Paddington United Submissions to Application Number SSD-97528708

Submission to Application Number SSD-97528708
Mixed Use Development with Infill Affordable
- 160 Oxford Street, Paddington

Architectural Drawings (Document F of the EIS, p.40)

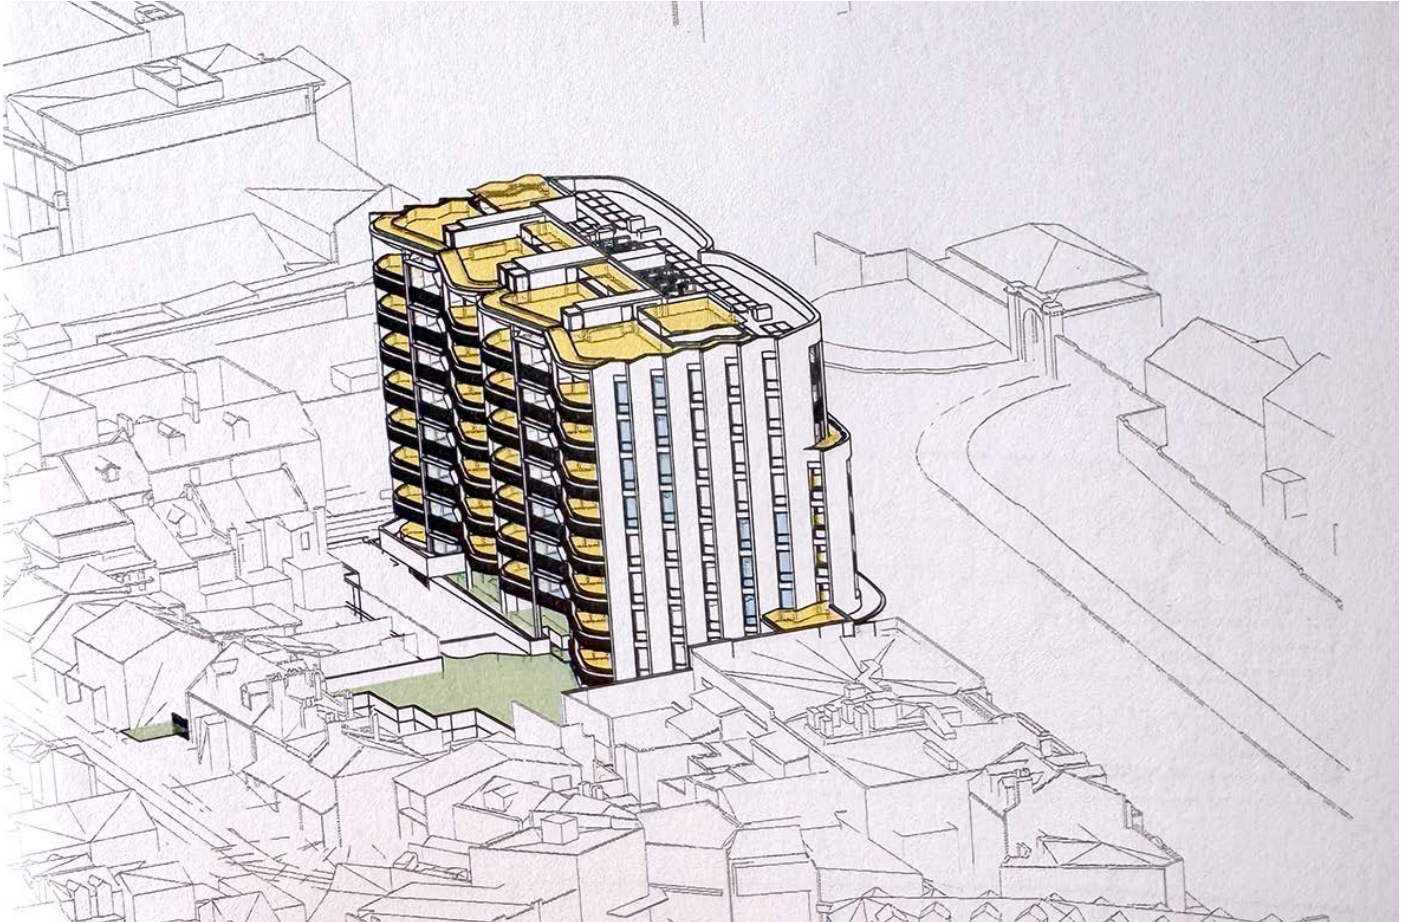
The proposal contains multiple and substantial non-compliances with mandatory planning requirements and the SEARs Requirements. The most significant issues include:

10 Architectural Design Report (Document G of the EIS), p.137.

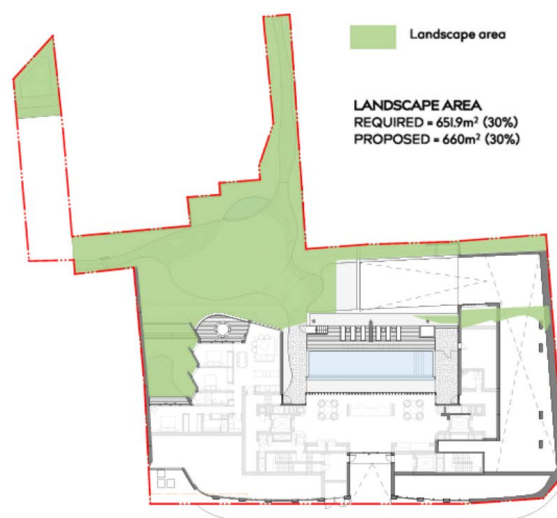
- Without the legal right to vary Bethel Lane or provide access from the site to 13 Gipps Street, it is clear that 13 Gipps Street is independent and for all purposes will not be accessible by anyone other than the residents of 13 Gipps Street (and will remain a separate lot). It is subject to only minor landscaping changes and will otherwise largely remain in its current state, including a secure high fence around its front yard.

- If two areas of the site are unconnected (notwithstanding they are adjacent), neither can be considered “subordinate” to the other in a functional sense, as they are physically separate. The lack of physical and functional connection means they cannot share planning benefits that apply to the other zone.

- Accordingly, it must be severed and zoning of the site must be applied consistently, and this includes for the purposes of meeting any thresholds. This has been included as item 2 in the Recommended Conditions.

Visual Impact Assessment (Document U of the EIS)¹⁴²

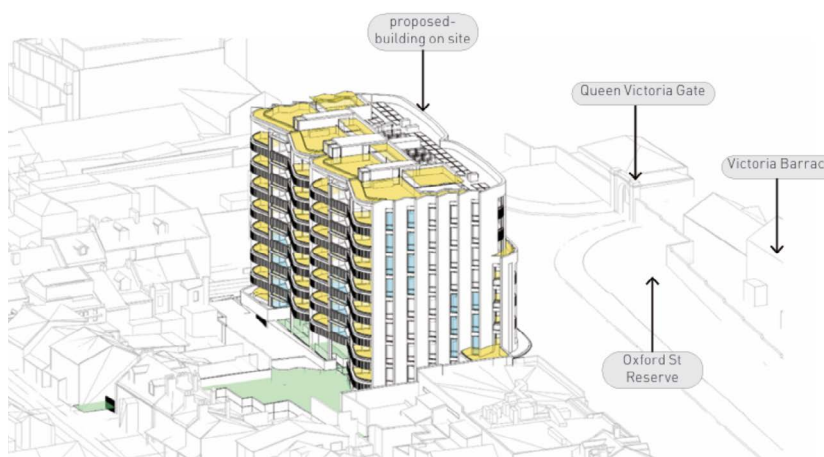
- By way of final example, there is a strong reliance on concealment provided by the London Plane trees. The EIS generally relies heavily on photos with the London Plane trees with full leaf coverage, and states that the excessive height of the development will be substantially concealed by the London Plane trees. We refer to figures 18 and 19 on page 37 of the EIS by way of example. This point is repeated in the EIS as a mitigation for the excessive height. The EIS claims: “They (the trees) will partially obscure/screen the first five storeys of the development when viewed from Oxford Street.”¹⁴⁴

Windows of 21 Gipps St overlooking battle-axe.

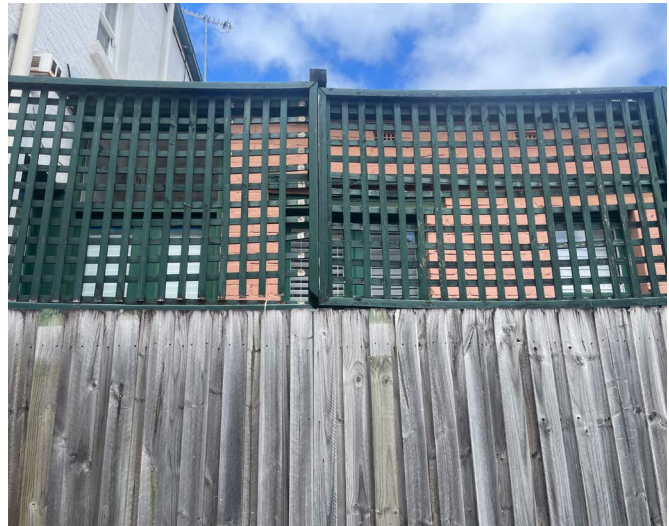
- 23 Gipps St has an outdoor area which extends along part of the battle-axe and has multiple windows which overlook the battle-axe from the kitchen area. The bedrooms for the dwelling are on the top floor and overlook the battle-axe.
- There will be a substantial loss of privacy through the windows (particularly for the bedroom), noise transfer (including to a window of a bedroom) and acoustic privacy loss from the outdoor area, and increased security concern.
- Save for the vents and rear gate, the amenity impacts outlined above for 21 Gipps Street apply equally to 23 Gipps Street.

Shadforth Street

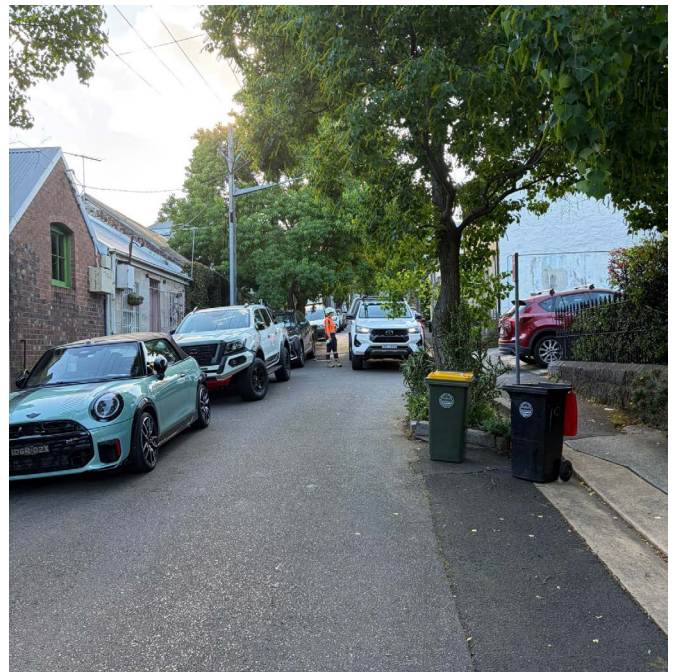
- As the only two-way street between Glenmore Road and Jersey Road, Shadforth Street serves as an important and very busy thoroughfare, notwithstanding its narrow width (~4.1 metres).
- It is also regularly used by vehicles to bypass the traffic lights at the Glenmore Road/Oxford Street intersection.

Map of Oxford Street Buildings

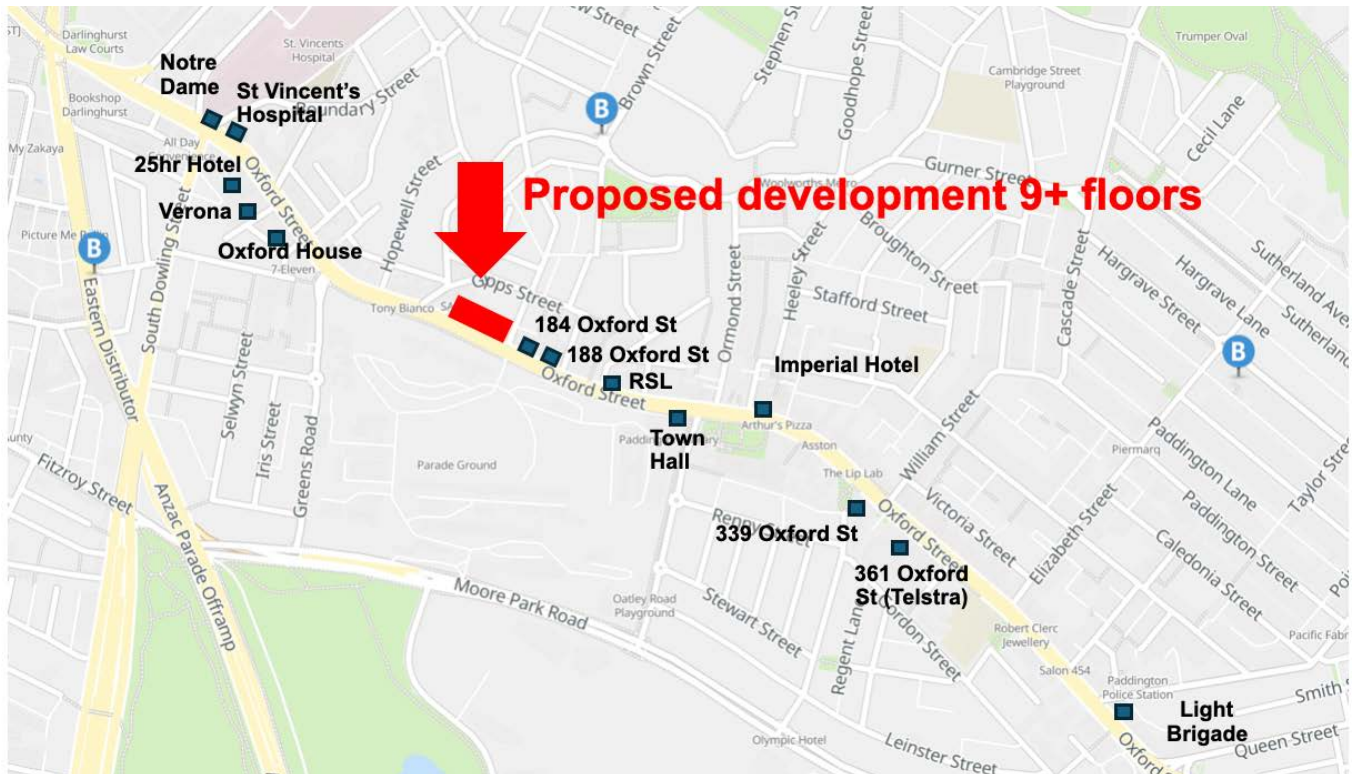
There is **only 1** building over 6 floors between St Vincent's Hospital and Jersey Road Paddington, and it is located in the City of Sydney Council, being 339 Oxford 8 levels (apartment)
